GOOD NEIGHBOR AGREEMENT

The GNA and Major Amendment 014

Major Amendment 014 (MA014) proposes to authorize expansion of the Hertzler Tailing Storage Facility (TSF) and East Side Waste Rock Storage Facility (ESWRSF) at the Stillwater Mine, which extends the life of mine by approximately 40 years. The current waste rock storage and tailings storage facilities will reach capacity within the next 3-5 years.

Proposed ESWRSF expansion

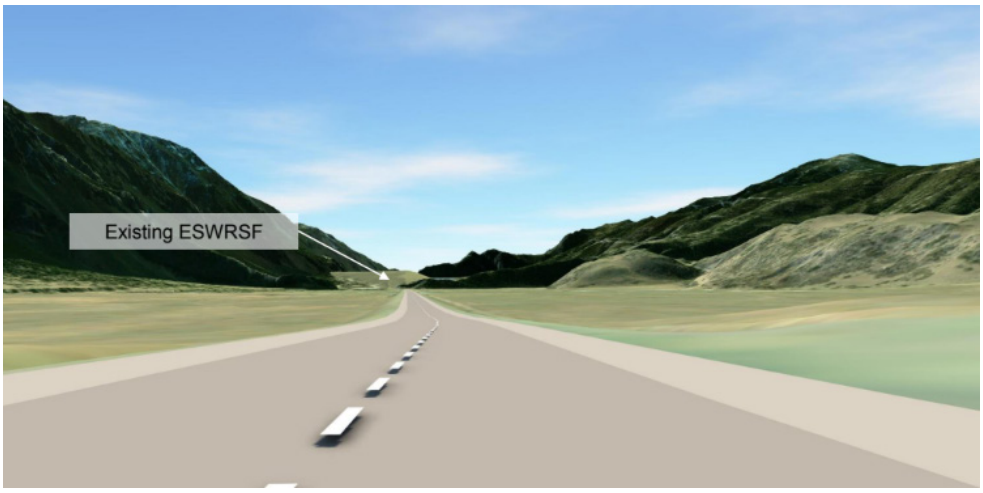
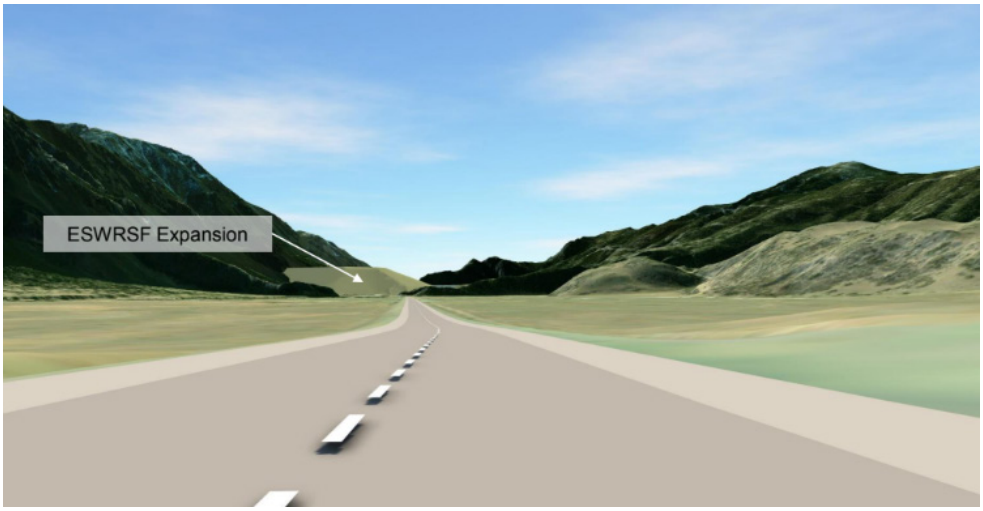
- **Incorporate Geomorphic Reclamation Techniques in the Facility's Outer Slopes.** Integrate natural landform restoration approaches to improve ecological resilience, reduce erosion, and create habitat continuity that mirrors the surrounding landscapes' natural topography.

- **Consider Large Storm Events in Design Plans.** Incorporate adaptive design features that anticipate increased storm intensity and frequency, including enhanced stormwater management systems to prevent flooding and contamination risks.

- **Bolster the New Boundary of the Waste Rock Pile.** Strengthen containment measures at the waste rock pile's new boundary to prevent contamination from waste rock leachate, given its close proximity to Nye Creek and the Stillwater River.

- **Disclose Existing Water Quality Impacts from Waste Rock Leachate.** Ensure adequate and protective water quality monitoring through the use of monitoring wells to provide comprehensive data on groundwater quality and detection of any potential contamination around the facility.

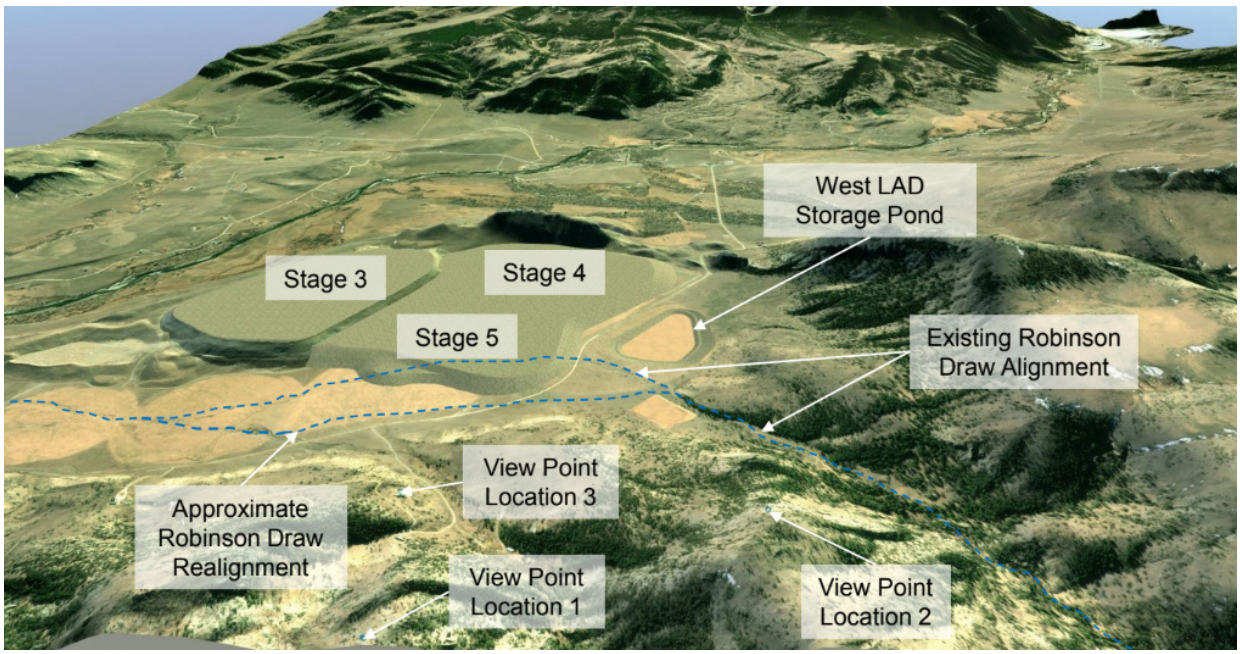
- **Evaluate the Feasibility of Filtered and Thickened Tailings.** We encourage robust evaluation of alternative tailings processing methods that reduce water content, improve stability and reduce the risk of seepage and water quality impacts, while also allowing for disposal of more tailings within the same footprint.

- **Require Incorporation of Geomorphic Reclamation Principles into the Design Prior to Construction.** Continue prioritizing natural landform restoration techniques during initial design phases to support early vegetation establishment, soil stability, and long-term ecosystem recovery. We also recommend future review of best practices of reclamation practices as new technologies are developed and implemented.

- **Ensure Adequate and Protective Water Quality Monitoring Wells.** We recommend monitoring wells around the TSFs to provide comprehensive data on groundwater quality to detect any potential contamination as close to the facility as possible.
